From: Linda Whetton
To: Begay, Steven; Broscheid, Bob; Bulletts, Charley; Gold, Rick; Groseclose, Jay; Jackson Kelly, Loretta; James, Leslie; Kuwanwisiwma, Leigh; Lehr, Phillip; Martin, Steve; Potochnik, Andre; Rampton, Ted; Ramsey, Nikolai; Sabo, David; Seaholm, Randolph; Shields, John; Spiller, Sam; Steffen, Mark; Stevens, Larry; Strong, Dennis; Warren, Brad; Werner, Bill; Zimmerman, Gerald
Date: 8/16/2007 9:38:14 AM
Subject: AMWG Proposed Budget and MRP Changes

From: "Mary Orton" <mary@maryorton.com>
To: "Linda Whetton" <LWHETTON@uc.usbr.gov>
Date: 8/15/2007 7:04:27 PM
Subject: Message to AMWG

Grand Canyon Trust – 2008 Hydrograph

COMMENTS ON THE MONITORING AND RESEARCH PLAN FROM LESLIE JAMES OF CREDA:

Figure 1. Monthly volumes from 1995 EIS. 200 kAF of water moved from January and February to accommodate a BHBF in March.

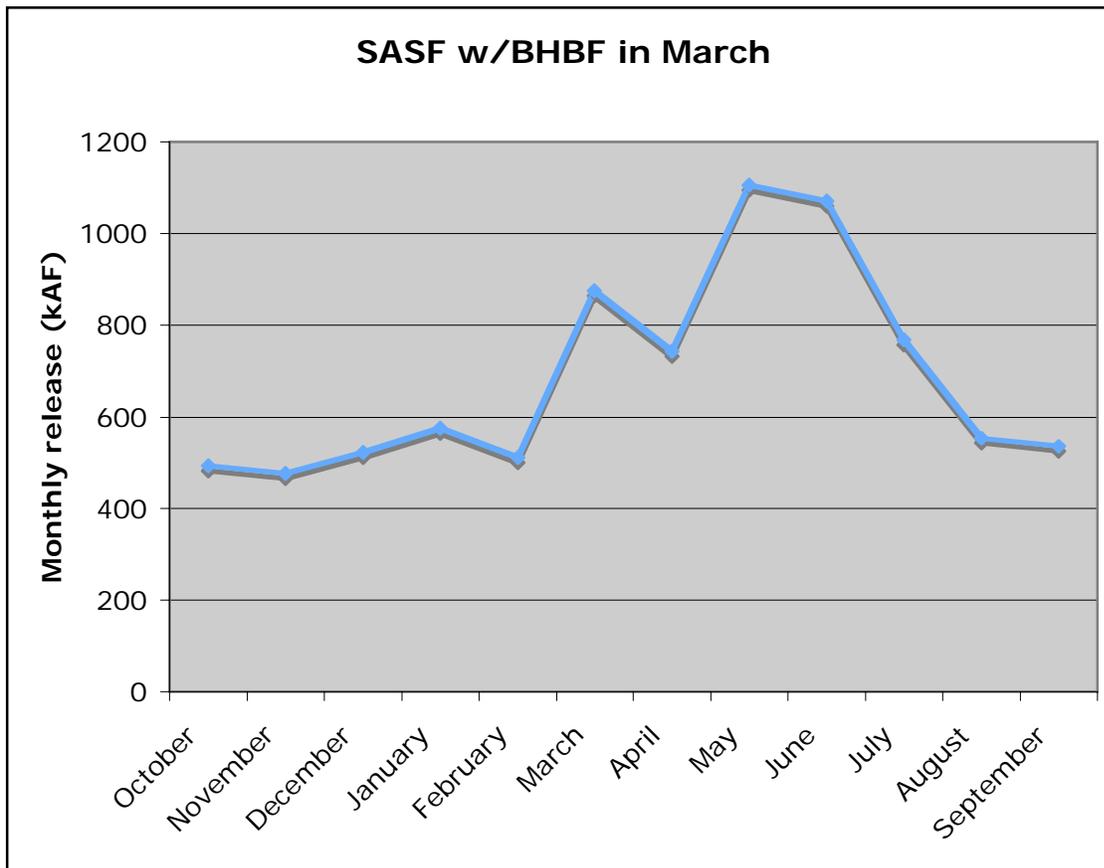
The 1995 EIS (USBR 1995) provides a hydrograph consistent with the requirements of the RPA (see Figure 1). In addition, a hydrograph (Valdez and others 2000) and a detailed science plan (Fritzing and others 2000) were developed for the 2000 Low Summer Steady Flow (LSSF) experiment. An updated hydrograph and science plan should be completed to reflect the most current scientific information regarding the effects of dam releases on humpback chub and its critical habitat.
